Submission by Mallard Pass Action Group (MPAG)
– unique ID ref. 20036230

ALC and BMV assessment – reports and background

Report on Mallard Pass Solar Farm ALC.

Critique of ALC Report

BSSS ALC Checklist

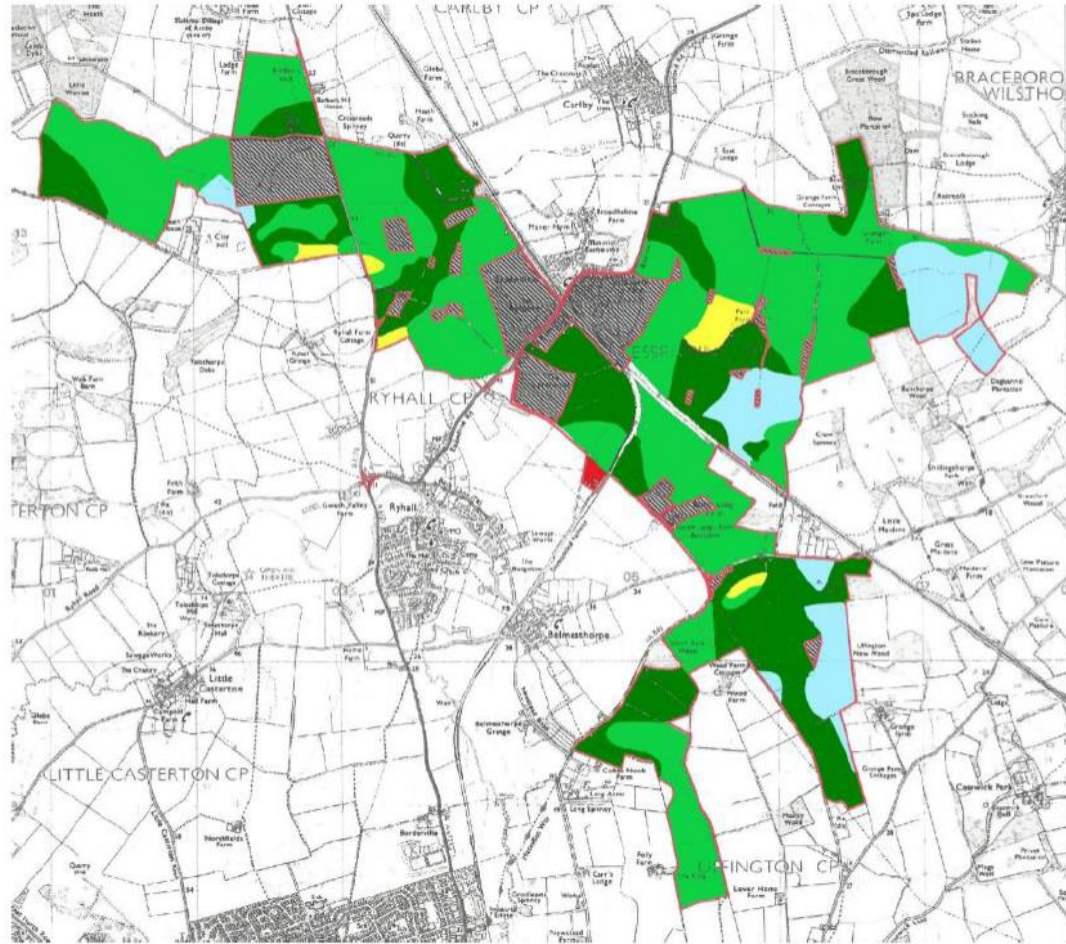
Has a schedule of auger boring information been provided?	PASS	In Field 2, 24 auger bores were made across 30 hectares. Ideally there would be 30 auger samples taken and around 2-3 pits.
	Do the auger borings show horizon depths, colours & textures?	PASS	
	Do the auger boring records clearly show soil wetness class?	PASS	
	Do the auger boring records clearly show topsoil stone content?	PASS	
	Do the auger boring records clearly show depth to gleying and depth to slowly permeable layer (SPL)?	PASS	
	Do the auger boring records clearly show moisture balance (MB) values for drought (Wheat & Potatoes)?	PASS	
	Has detailed soil pit information been provided in the report and do the pit descriptions show horizon depths, colours and textures?	CONCERN	No soil pits dug in Field 2
	Do the soil pits / pit clearly show soil wetness class (WC)?	CONCERN	No soil pits dug in Field 2
	Do the soil pits / pit clearly show moisture balance (MB) values for drought?	CONCERN	No soil pits dug in Field 2

Do the soil pit / pits clearly show soil structure and porosity in the subsoil?	CONCERN	No soil pits dug in Field 2

DRAWING TITLE
Figure 12.1: Agricultural Land Classification Results

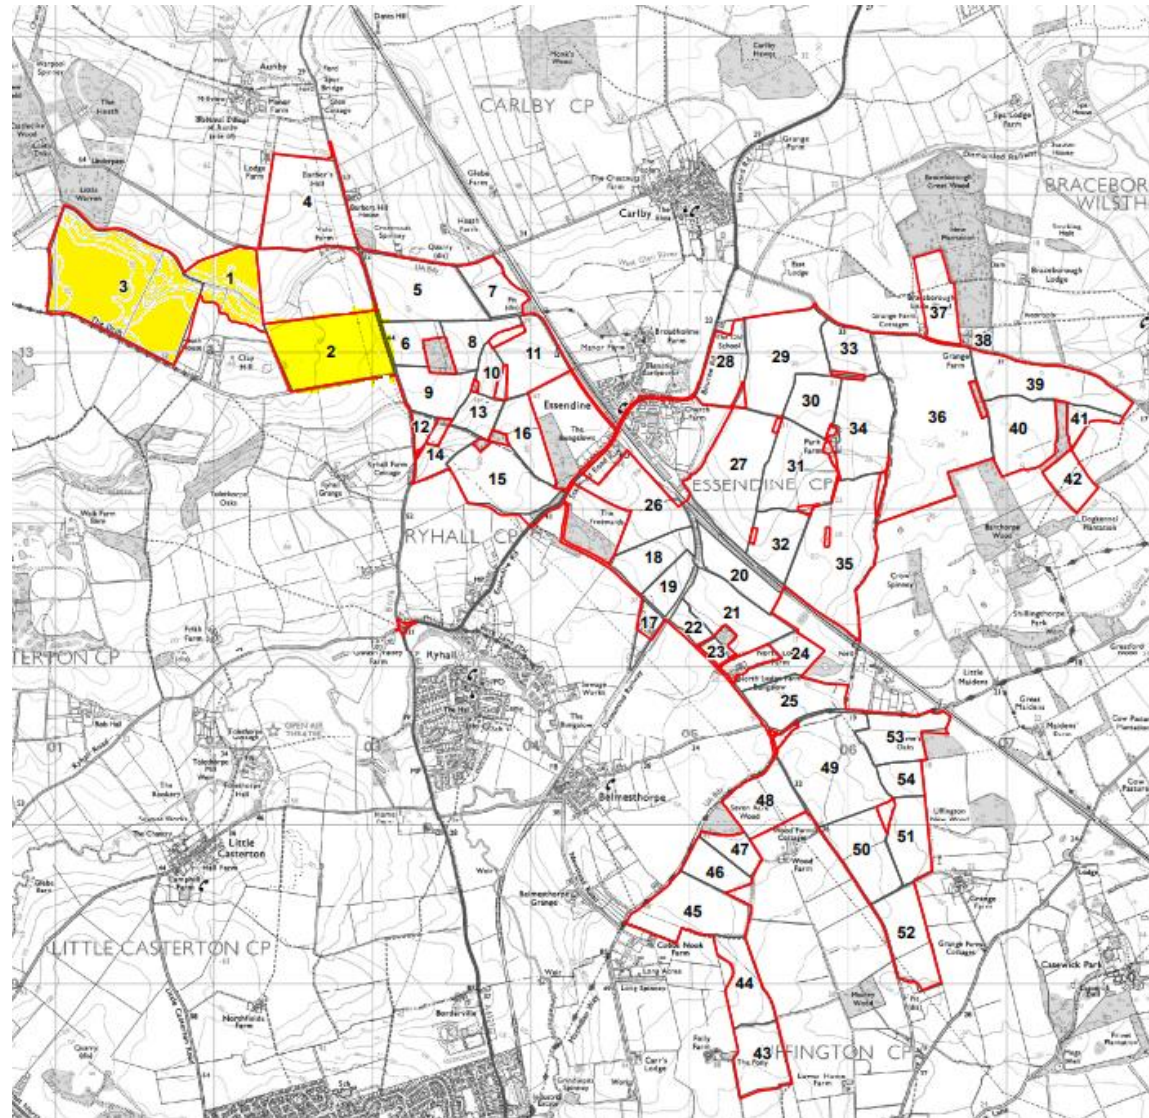
5.6 Points 14 and 15 were found to be similar to the KCC findings, except that point 15 was a deeper profile, suggesting that the land is in fact Grade 3b rather than Grade 4. A further sample point was taken in this area for clarification. In general, the area of Grade 4 is about half that found by KCC. The attached **Plan 3** shows the ALC grade map.

7.2 With the time available, we were not able to undertake a full ALC assessment over the entire area as this would have taken several days and we did not have access to the land. Nevertheless based on the sample findings of the auger borings on land considered in the KCC report not to be BMV, we still found BMV land across the site, mainly 3a and some Grade 2. In the case of Field 2 we consider that the area of Grade 4 is too large and more likely this land is mostly Grade 3b.

Plan2 (Field 2) Showing Auger Points and Soil Pits

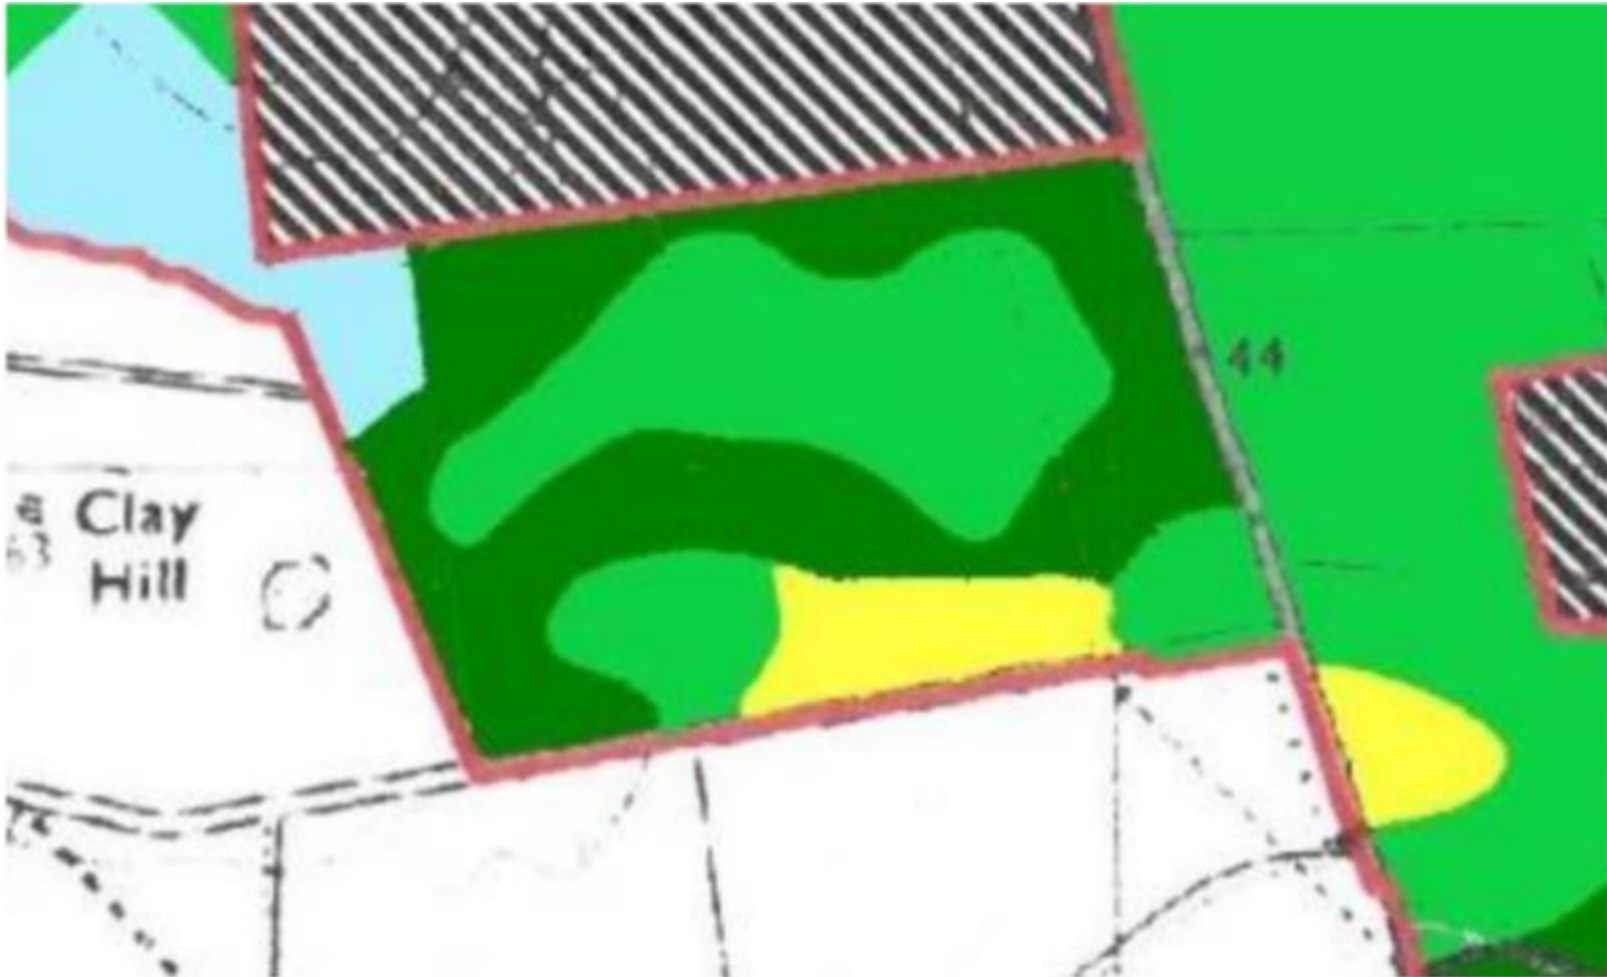
5.3 A total of seven samples (**Plan 2**) were taken in this field in the locations identified as Points 2, 6, 7, 9, 11, 14 and 15. Soil pits were dug to investigate the soil profiles.

5.4 Generally, soils were similar at points 2 and 6, but with deeper profiles at point 7 and 11. Broadly we concur with the findings of the KCC report that the area contains 3b, but we consider there is more 3a land than stated in the second report. There is clearly local variation with stoniness and relative shallowness of soils, variable across the site.

5.5 Point 9 was found to be much deeper and found to be Grade 2 land. A soil pit was dug at this location and significant stone was not found until 90cm depth. We consider that this widens the area of Grade 2 at this point rather than reduce it, as has happened in the KCC report.

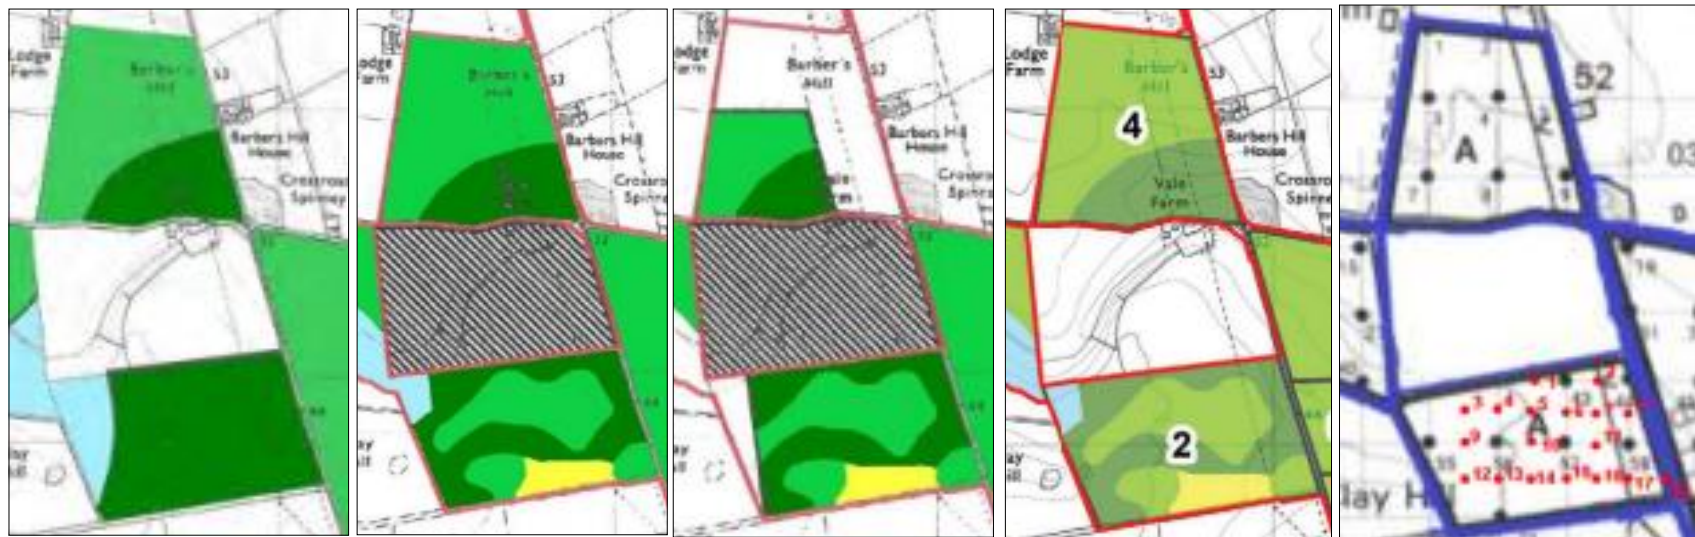
The change: the RHS of filed 3 is mitigation as is the bottom of field 1

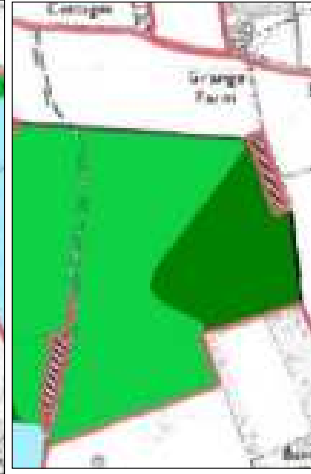
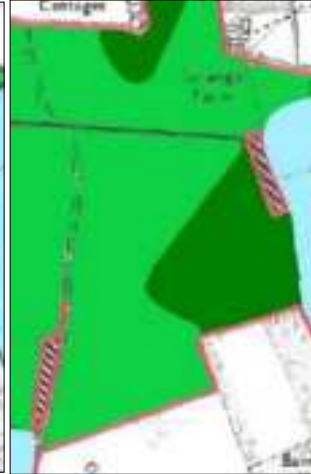
No phase 2 auger sampling so why is there less 3a than before, & grading missing on stage 2 solar area pic (fields 18&19)

4. Auger Points Plan

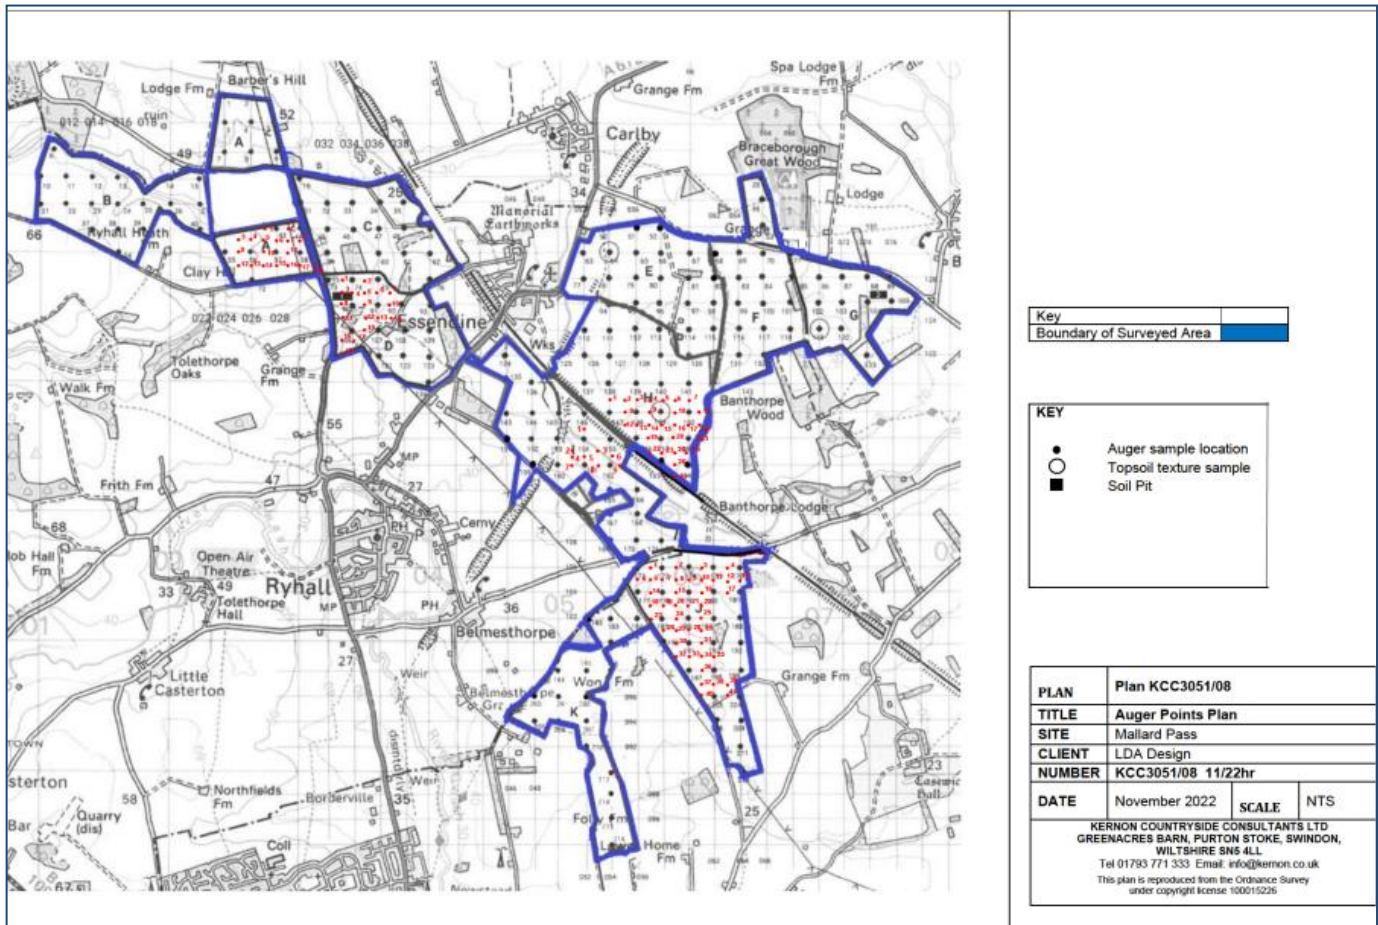
- Black dots denote stage 1 lower density sampling. Red dots denote stage 2 higher density sampling – selected in just **5 areas** that were identified in stage 1 sampling to be BMV.

- There are **only 2 soil pits** with data for the **whole site**, 1 in field 39 south of Carlby Road which is retained arable grade 2, and 1 in field 9 adjacent to the B1176 which is one of the very few parcels graded 4. Soil pits are crucial for informing ALC results following auger boring. Without them it is not possible to provide a robust ALC assessment.

- Only **11 samples of soil were lab tested** but they were randomly picked across the different site areas, as opposed to testing multiple times in any one field parcel. Given the variability of soils within field parcels, this could not adequately inform any ALC grading.

- The Applicant mentions **10 trenches**, only identifies 3 in pictures, namely **trench 2, 4 and 7** and draws no direct links from the trenches to their results. Those 3 trenches are all in field 36, that location was graded 3b. It would seem given the early trench no.s that the KCC survey work only just coincided with the start of the trial trenching work, otherwise surely there would have been examples of trenches all across the site with a cross section of trench numbers as over 200 trenches were dug by Cotswold Archaeology.
